Haweswater Aqueduct Resilience Programme - Proposed Bowland Section

Supplementary Environmental Information Report

Project No: B27070CT
Document Title: Proposed Bowland Section
Supplementary Environmental Information Report
Document Ref.: LCC_RVBC-BO_SEI
Revision: 0
Date: February 2022
Client Name: United Utilities Water Ltd

Illustration 2: Temporary Gamble Hole Farm Pasture BHS Crossing and Extent of Biological Heritage Site

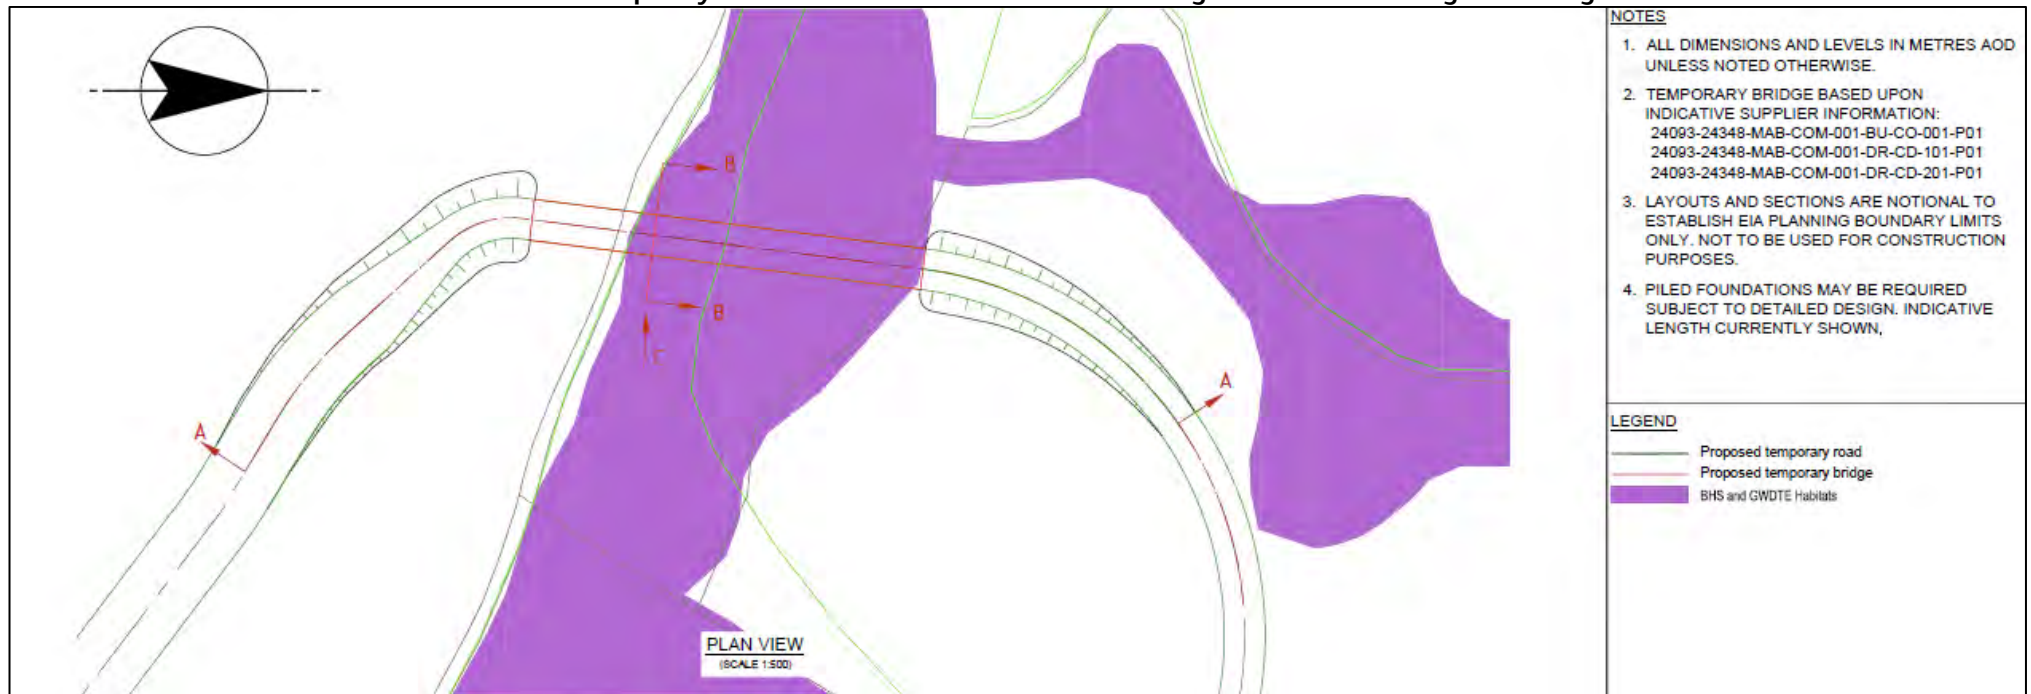
- Construction of a temporary bridge structure, within the current planning application boundary for the Newton-in-Bowland Compound, to span over a sensitive habitat known as Gamble Hole Farm Pasture Biological Heritage Site (BHS)

- Additional off-site highways works to the south-west of Bentham, and revised construction traffic access proposals for the Lower Houses Compound
 - Construction, within the current planning application boundary of the Newton-in-Bowland Compound, of a temporary bridge structure to span over a sensitive habitat known as Gamble Hole Farm Pasture Biological Heritage Site (BHS)

SCALE 1:10,000	SHEET SIZE A3
DRAWING NUMBER LCC_RVBC-BO-FIG-003-001A	REVISION 1

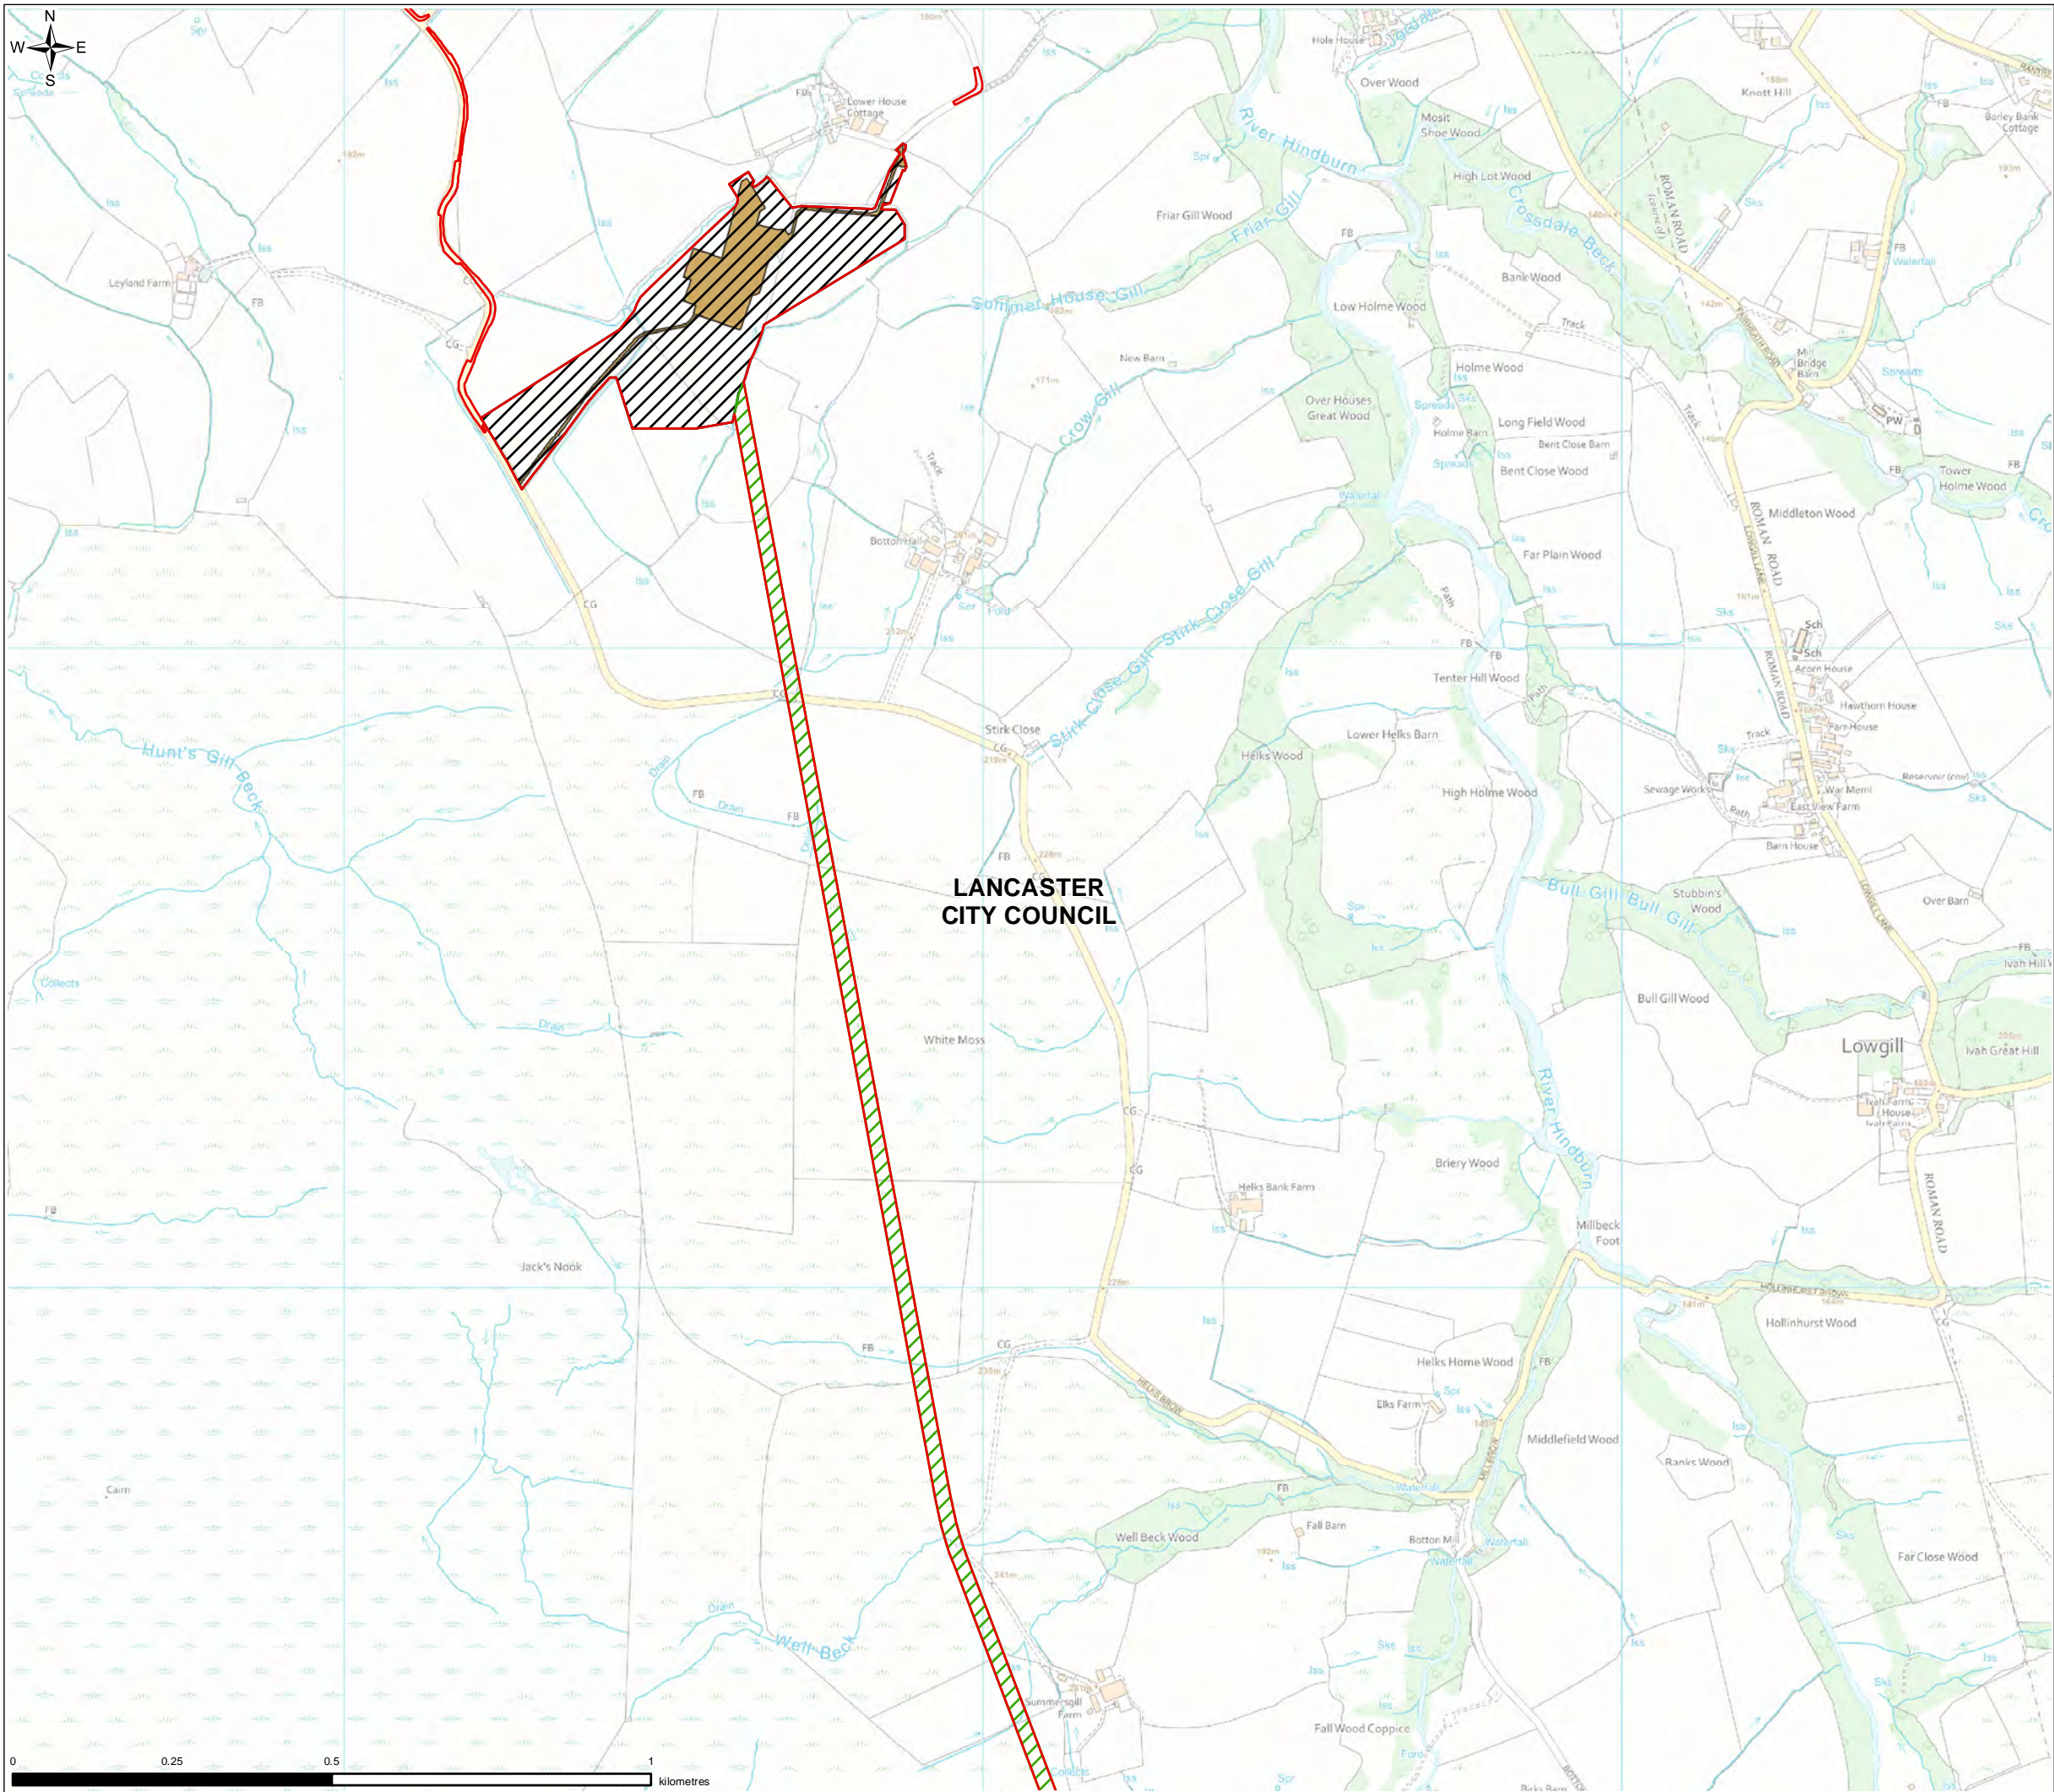
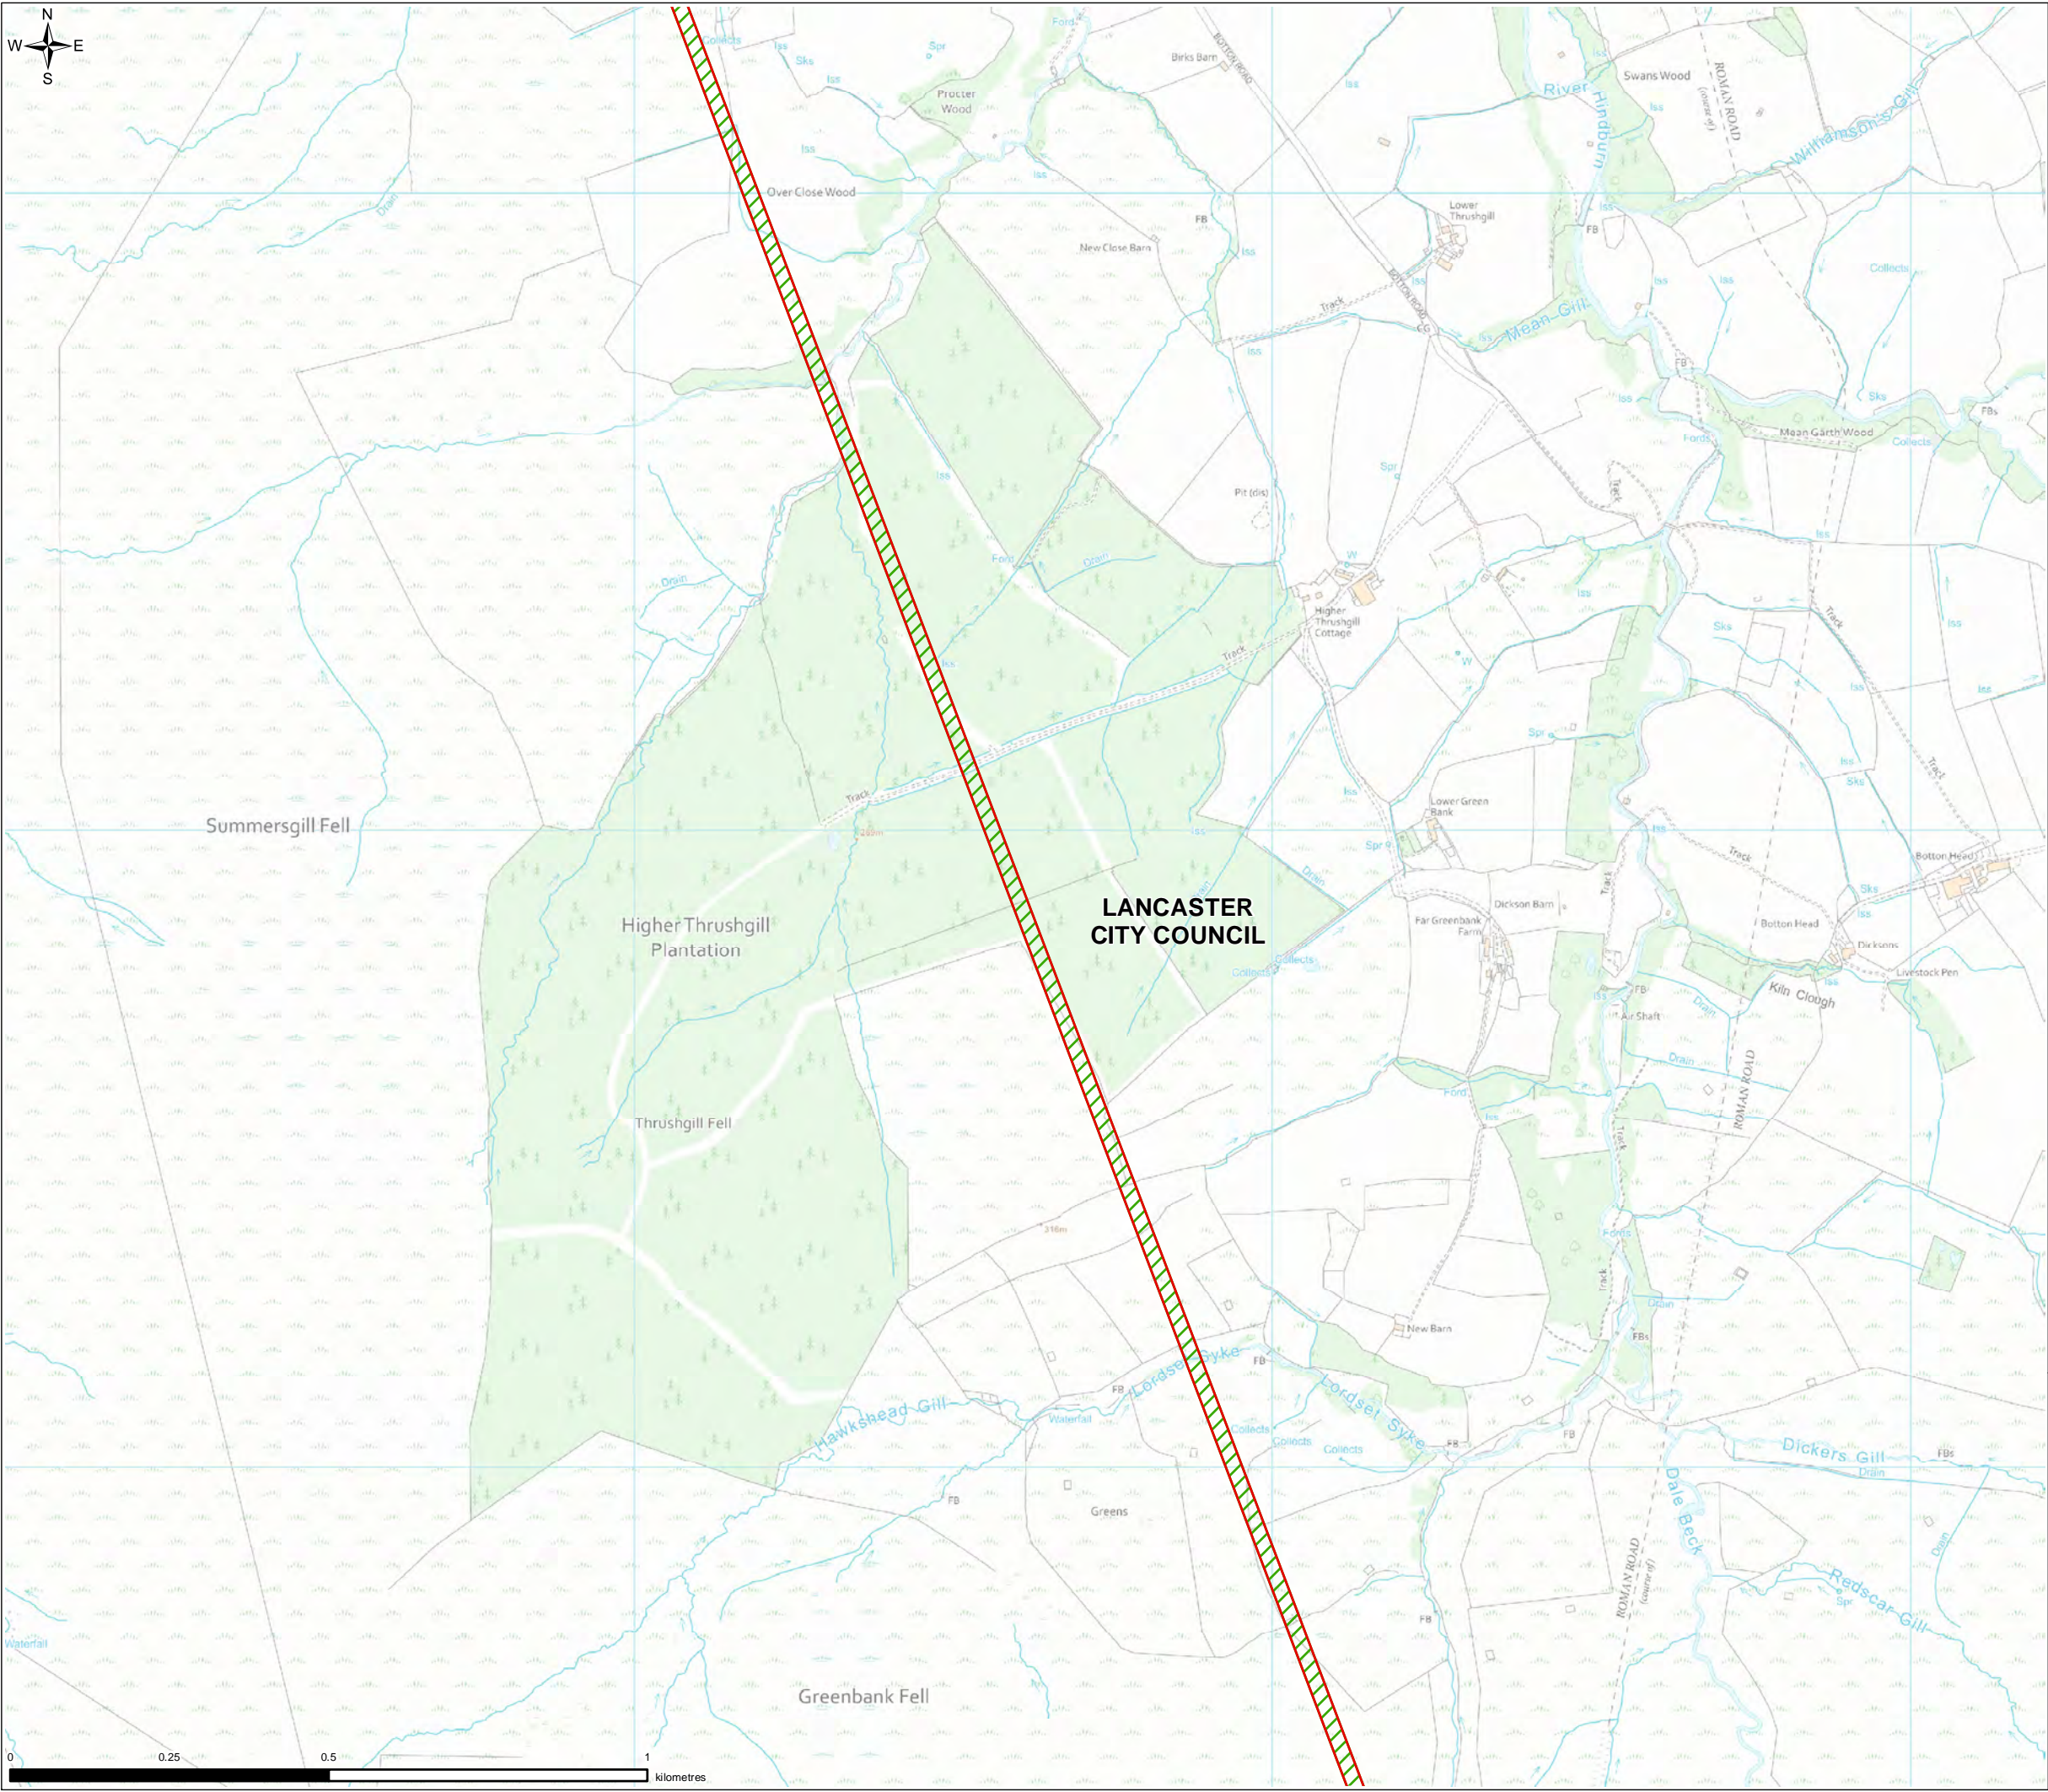
- 28) Figures 3.1a and 3.1b present the updated planning application boundaries for the Proposed Bowland Section; more detailed and larger scale drawings are provided in the February 2022 Revised Planning Application documents. Figure 3.1a focuses on the main construction compounds and the route of the tunnel below ground level. Figure 3.1b shows all the elements of the Proposed Bowland Section at a smaller scale, including satellite compounds and off-site highways works.
- 29) A screening exercise has been undertaken to identify where likely significant effects may arise in relation to the changes and new proposals. This has involved testing the proposed changes against each EIA topic to establish whether any likely significant effect may arise. The outcomes are summarised in Table 6.
